Georges River Local Planning Panel

LPP010-23	13-21 Wyuna Street, Beverley Park – MOD2022/0204 (Report by Principal Planner)
------------------	--

LPP Report No	LPP010-23	Development Application No	MOD2022/0204
Site Address & Ward Locality	13-21 Wyuna Street, Beverley Park Kogarah Bay Ward		
Proposed Development	S4.55(2) Modification of development Consent No. DA2019/0439 for demolition, tree removal, construction of a 7 storey residential flat building with basement parking		
Owners	Mr Coplin, Mrs Coplin, Wyuna Group P/L		
Applicant	Wyuna Group Pty Ltd		
Planner/Architect	Architect: Shiro Architects Planner: Think Planners		
Date Of Lodgement	20/12/2022		
Submissions	One (1) submission		
Cost of Works	Original DA \$16,421,429.00		
Local Planning Panel Criteria	The application relates to development to which the State Environmental Planning Policy No 65 – Design Quality of Residential Apartment Development applies and the application has been lodged under Section 4.55(2) of the Act.		
List of all relevant s.4.15 matters (formerly s79C(1)(a))	State Environmental Planning Policy No.65 – Design Quality of Residential Apartment Development, State Environmental Planning Policy (Resilie

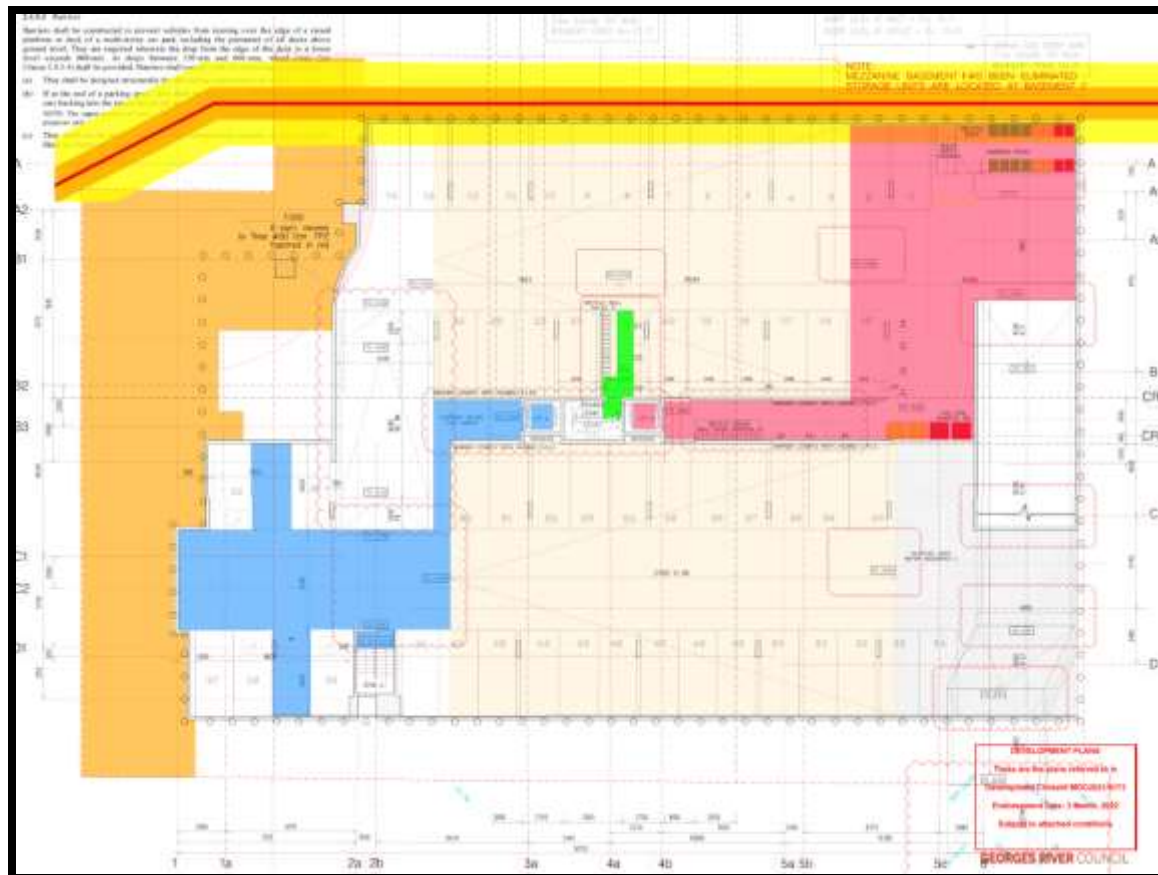
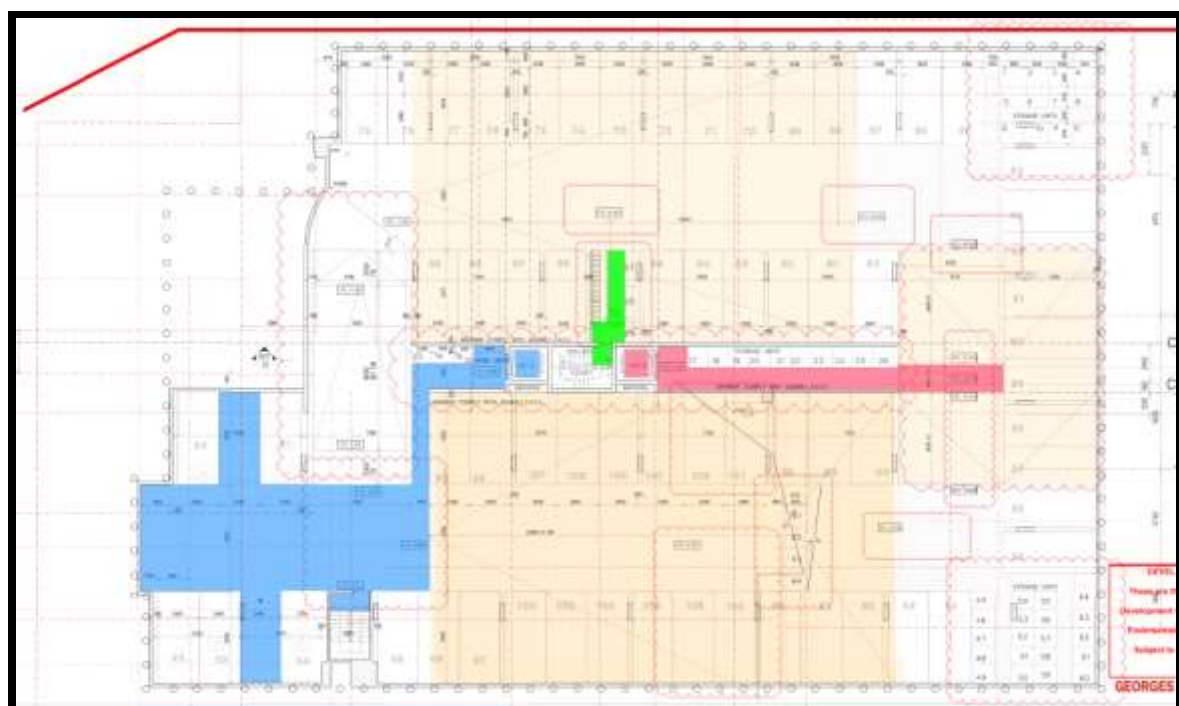
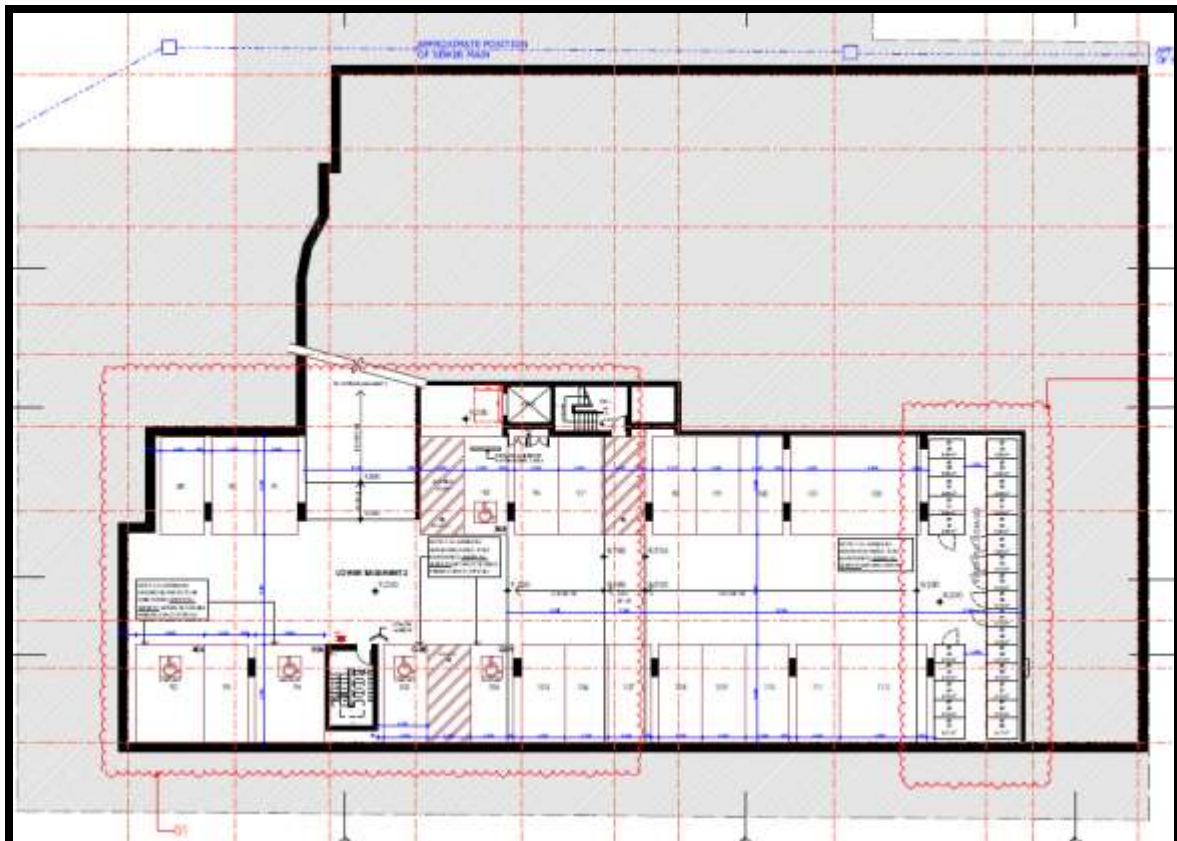
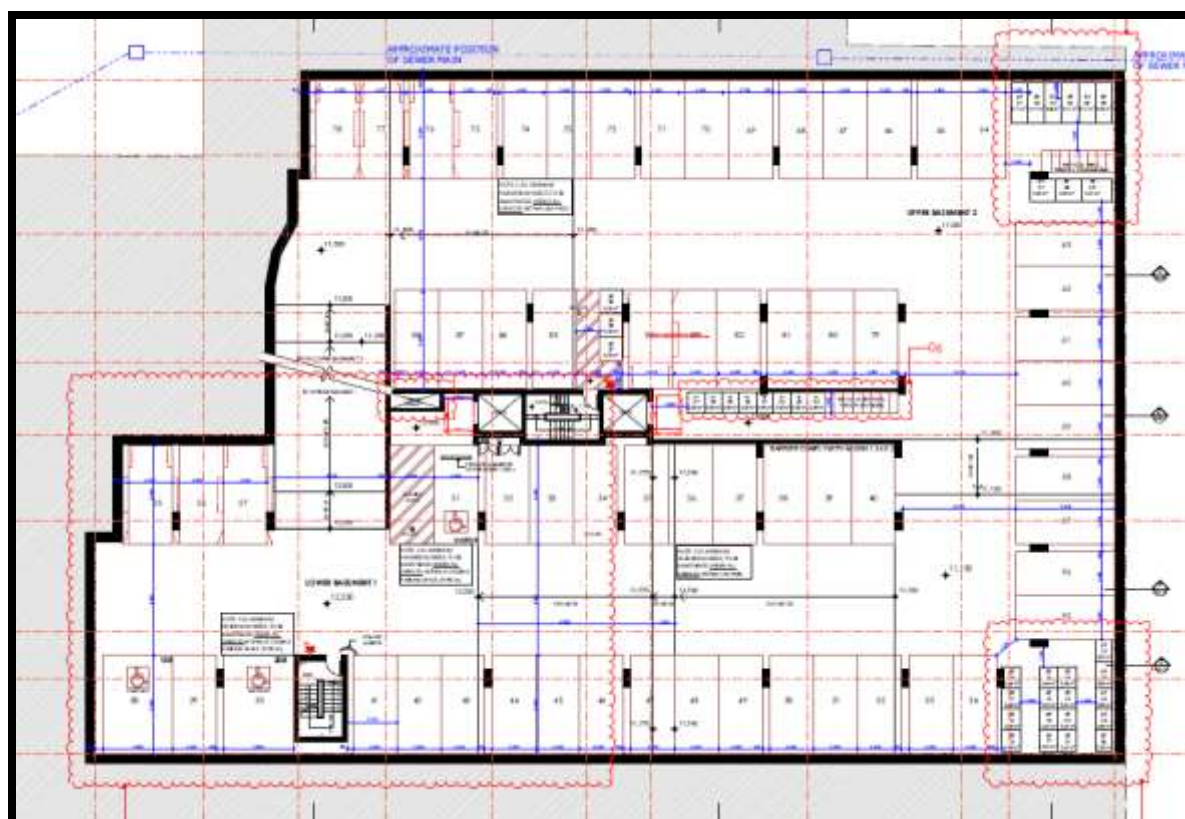
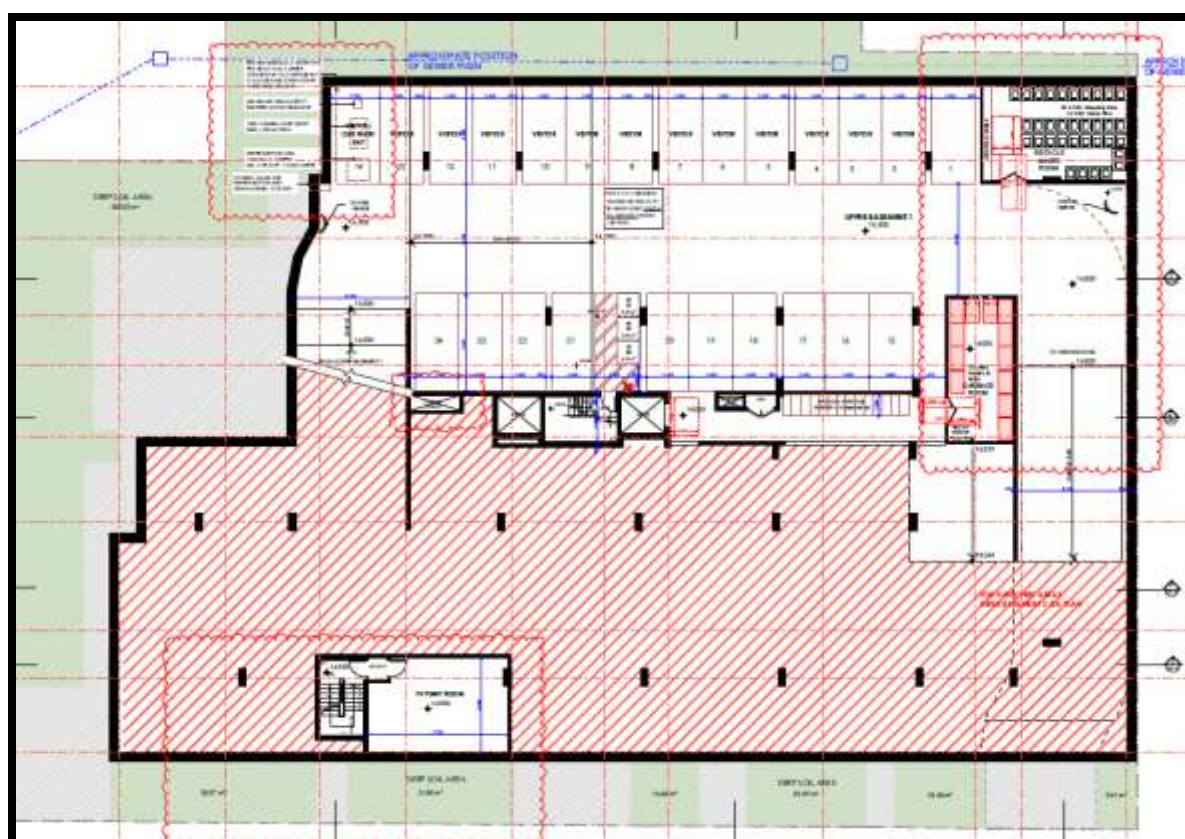
- Refinement of the basement car parking levels including reducing the floor to ceiling height of the upper basement from 3.7m to 2.7m and changes to the internal layout of the basement level that increases the number of car parking spaces from 109 to 114 and relocates storage areas;

Section 4.55(2) Considerations

57. In relation to parking, the following changes are proposed by this application:
- relocation/reconfiguration of the approved car parking spaces and bicycle/storage locations for better internal manoeuvring; and
 - increase in the total number of approved parking spaces from 109 to 114 (101 residential and 13 visitor spaces) (spaces 102 and 112 are double spaces).
58. The proposed basement changes are reproduced below:

S4.55 MODIFICATIONS

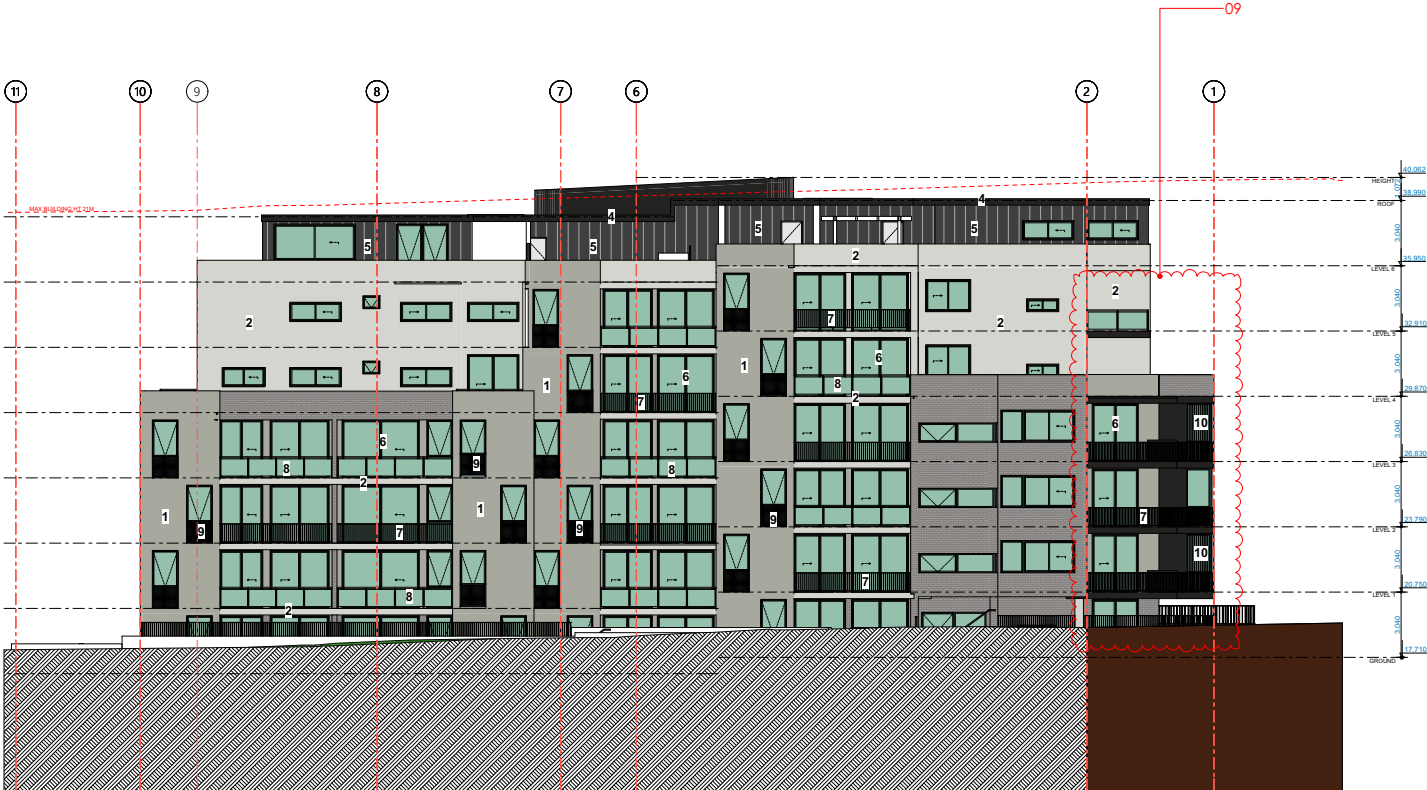
SCHEDULE OF AMENDMENTS:
01. The adaptable unit layouts have been updated and brevidle units have been introduced as per DA condition. Thus, the units layouts have been altered. Adaptable parking spaces altered.
02. Fit booster assembly have been introduced. Fit pump room is introduced in high ceiling area above the lower fit. Garbage rooms updated.
03. Basement carpark R/Ls have been modified to minimise the bulk excavation volume.
04. Minor changes in the total number of approved parking spaces from 109 to 112, whilst retaining the approved basement footprint.
05. Minor changes to materials and finishes.
06. Relocation & reconfiguration of storage units.
07. Changes to the internal layouts as a result of refinement and improving accessibility.
08. Minor changes to external stairs and levels.
09. Resizing/removal of openings.
